**PLEASANT PRAIRIE PLAN COMMISSION MEETING
VILLAGE HALL AUDITORIUM
9915 39th AVENUE
PLEASANT PRAIRIE, WISCONSIN
6:00 P.M.
AUGUST 25, 2014**

- A. Consider the request of Daniel Pratt, of Arco Murray, agent for the owner of Good Foods Group LLC, for approval of **Site and Operational Plan** for the construction of a 39,166 square foot addition to the facility located at 10100 88th Avenue in LakeView Corporate Park.

TO: Jean Werbie-Harris, Community Development Director
FROM: Doug McElmury, Chief Fire & Rescue Department
CC: Deputy Chief, Craig Roepke
Lt. Thomas Clark, Fire & Rescue Department
Peggy Herrick, Assistant Planner, Community Development
SUBJECT: Review of the Good Foods Expansion Plans
DATE: 22 August, 2014

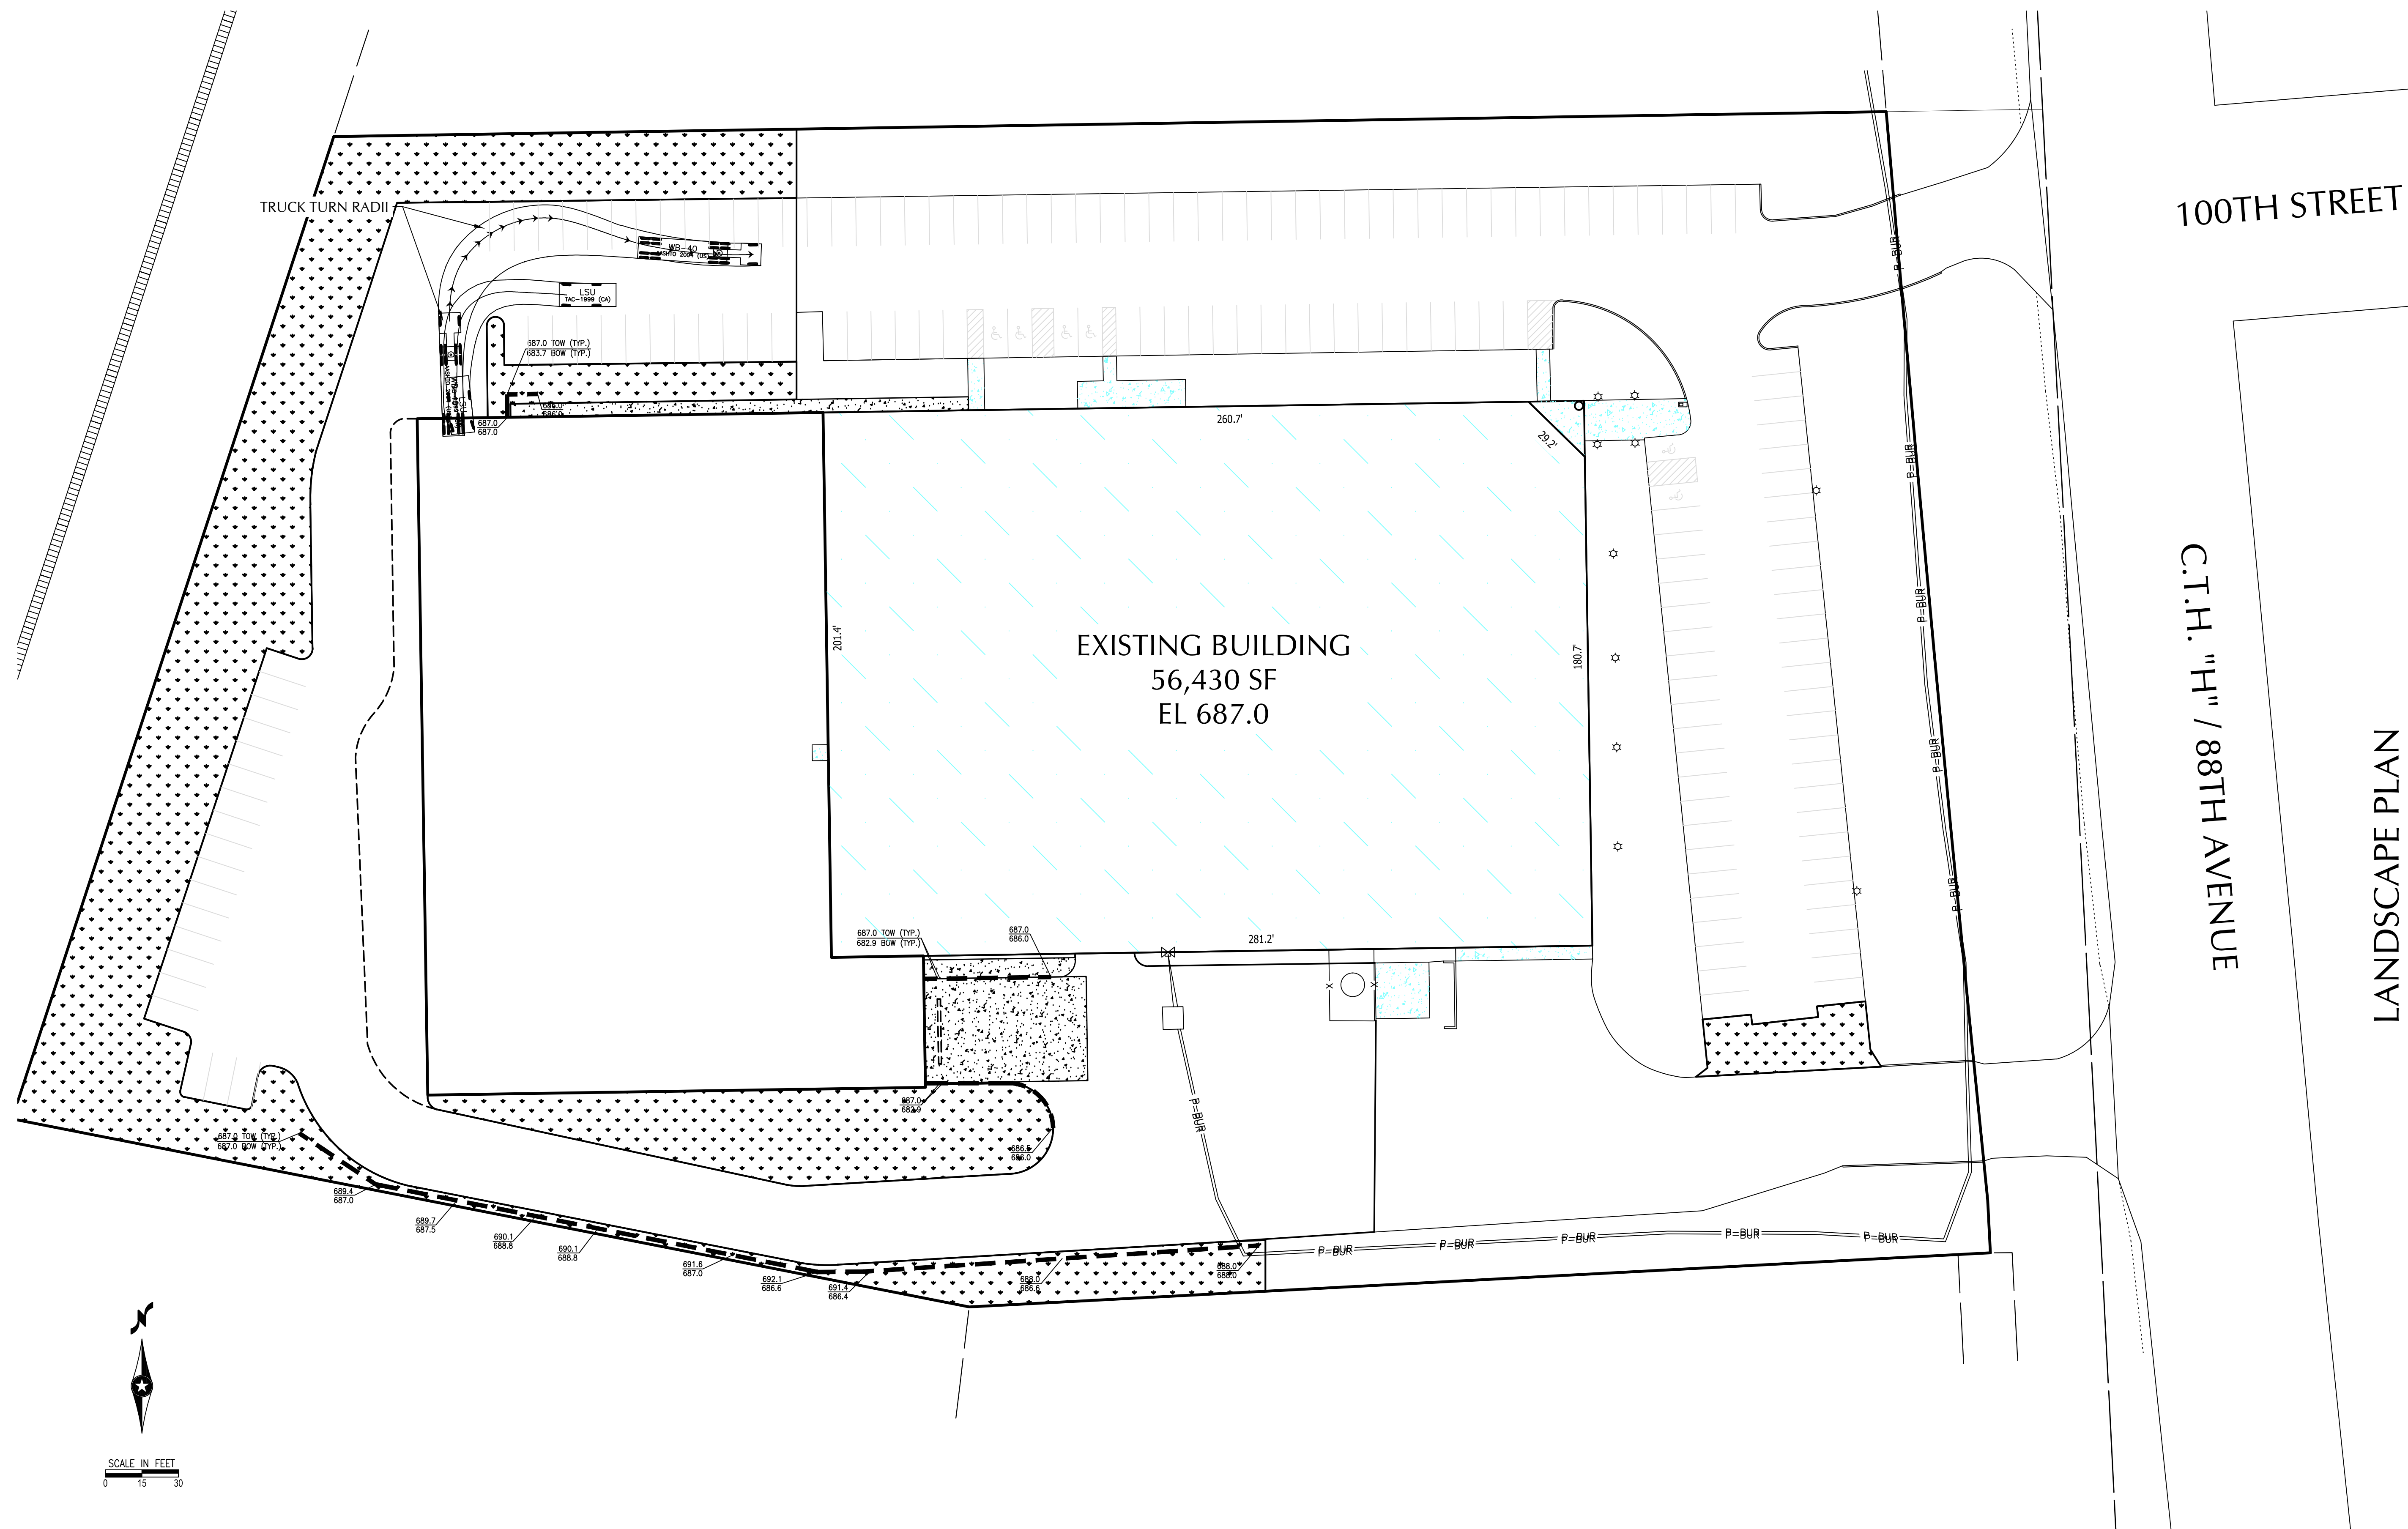
- h. Need to provide a detail of the proposed retaining wall along the south side of the property (height, materials, color, and cross-section).
- i. The proposed landscaping, or lack thereof, on the Landscape Plan (C-6), appears to be deficient (i.e. there are no new trees, shrubs, other plantings depicted).

- k. The truck turning movements for the at-grade truck door located at the extreme northwest corner of the building addition as shown on the Landscaping Plan (C-6) traverse through the designated parking spaces. How will truck maneuver if vehicles are parked in those spaces? Clarify/redesign.
